and Management Parameters for 10 Mb/s Operation and Associated Power Delivery over a Single Balance

Cl 00 SC FM P 12 L 28 # i-9
 Anslow, Peter Ciena
 Comment Type E Comment Status D Editorial
 The Editor's note: "New front matter text needs review." should be removed.
 SuggestedRemedy
 Review the text and delete the note.
 Proposed Response Response Status W
 PROPOSED ACCEPT IN PRINCIPLE.
 Delete Editor's note on lines 28-31

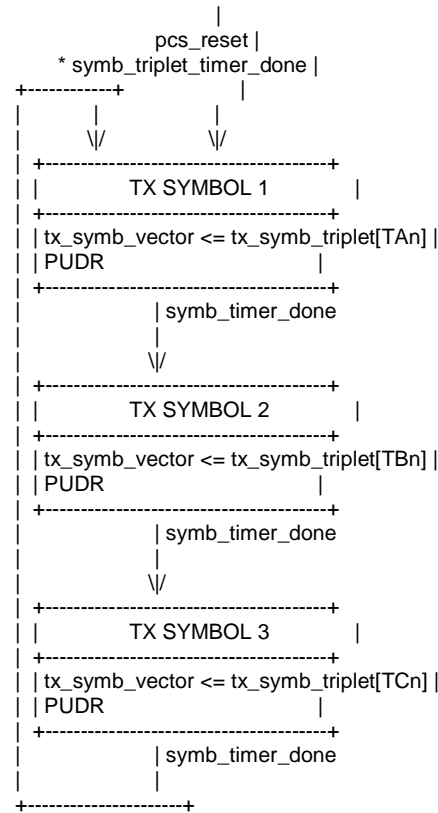
Is it correct that 'The PCS Transmit function shall conform to the PCS Transmit state diagram in Figure 146-5 ...' and that 'In each symbol period, PCS Transmit generates a symbol An provided to the PMA ...'? The PCS Transmit state diagram in Figure 146-5 changes state based on STD being true, with STD being an alias for symb_triplet_timer_done, and the output of the PCS Transmit state diagram is tx_symb_triplet which is defined in subclause 146.3.3.1.1 'Variables' as 'A triplet of ternary symbols generated by the PCS Transmit function after 4B3T encoding.'

I think the problem is that there is another function within the PCS Transmit function that is missing from the PCS Transmit state diagram in Figure 146-5, the 'multiplexor' shown in Figure 146-6 'PCS transmit symbol generation'. This 'multiplexor' function operates at the symbol clock rate and serialises the tx_symb_triplet code-groups output by the PCS Transmit state diagram into individual symbols.

This may also explain when subclause 146.3.3.1.3 'Timers' defines the symb_timer that is not used in the PCS Transmit state diagram in Figure 146-5.

[4] Add a new subclause 146.3.3.2.2 titled 'Timers'. Move the symb_timer definition from subclause 146.3.3.1.3 Timers to this new subclause.

[6] Insert a new Figure 145-6 shown below (view using a non-proportional font such as courier), renumbering the following figures as required.

[7] Add text to subclause 146.3.3 'PCS Transmit' that reads 'The PCS Transmit function shall conform to the PCS Transmit state diagram in in Figure 146-5 and the PCS Transmit multiplexor state diagram in 146-6, and their associated state variables, functions, timers, and messages.'
